Charlotte Historic District Commission Application for a Certificate of Appropriateness

Staff Review HDC 2019-00377

PROPERTY ADDRESS: 321 East Worthington Avenue

SUMMARY OF REQUEST: Accessory Structure

PROPOSED ELEVATIONS

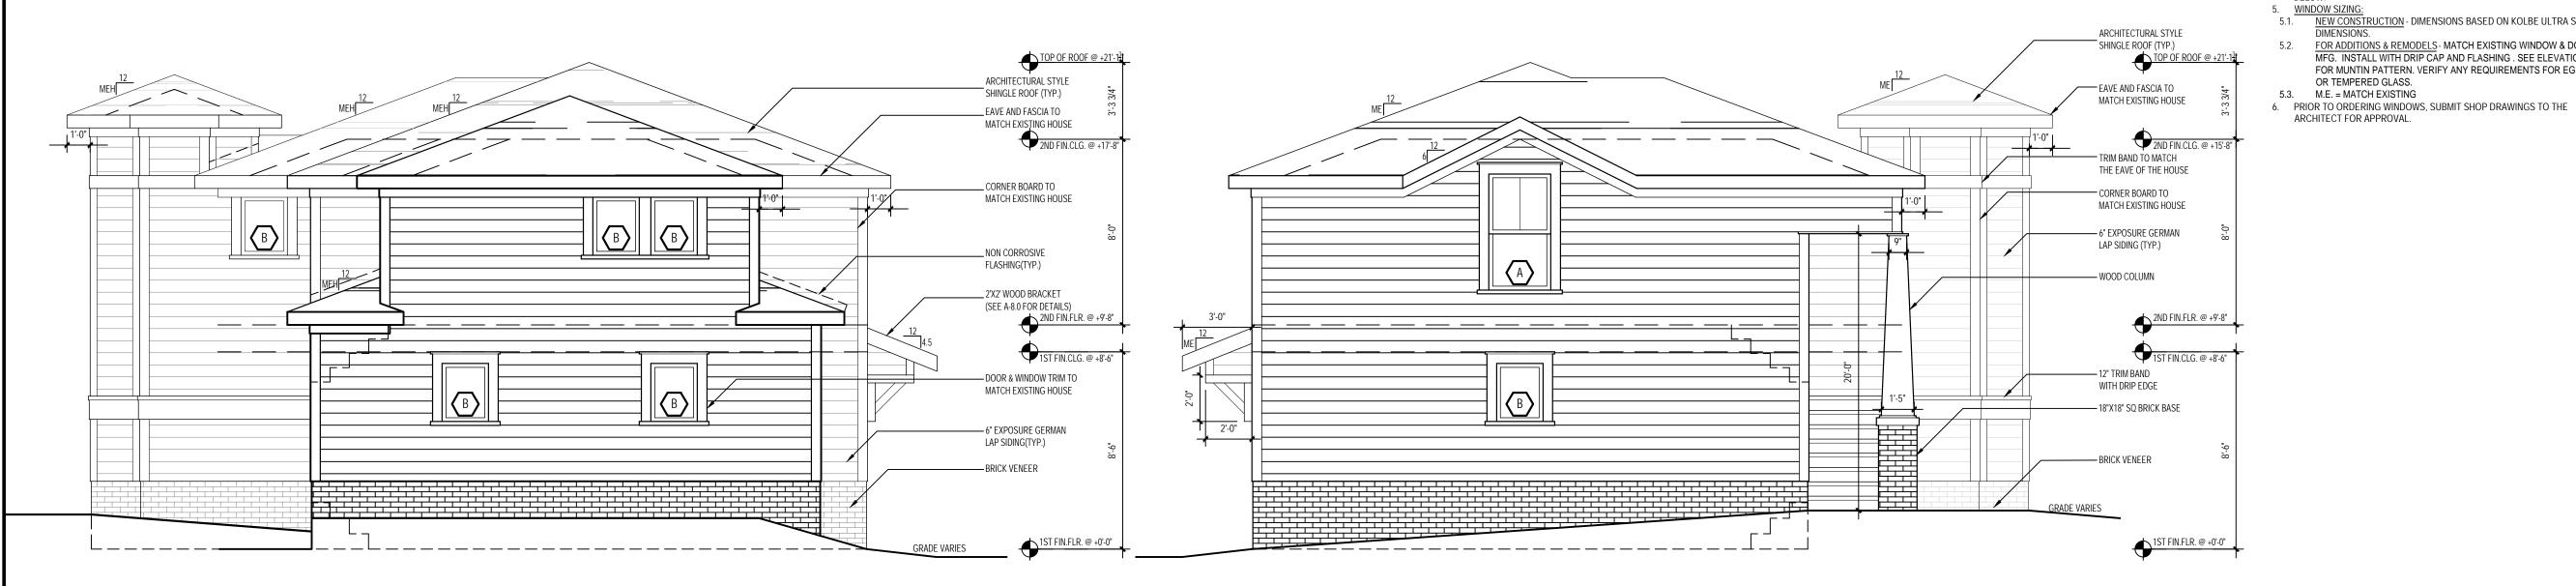
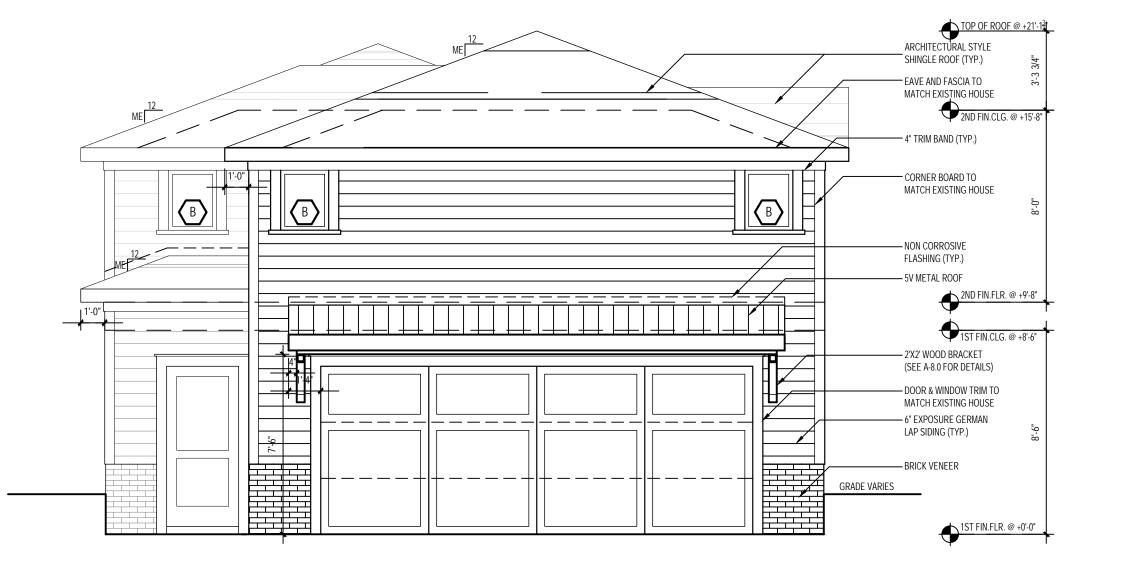
- 1. Height, massing, fenestration.
- 2. Minor revisions may be reviewed by staff.
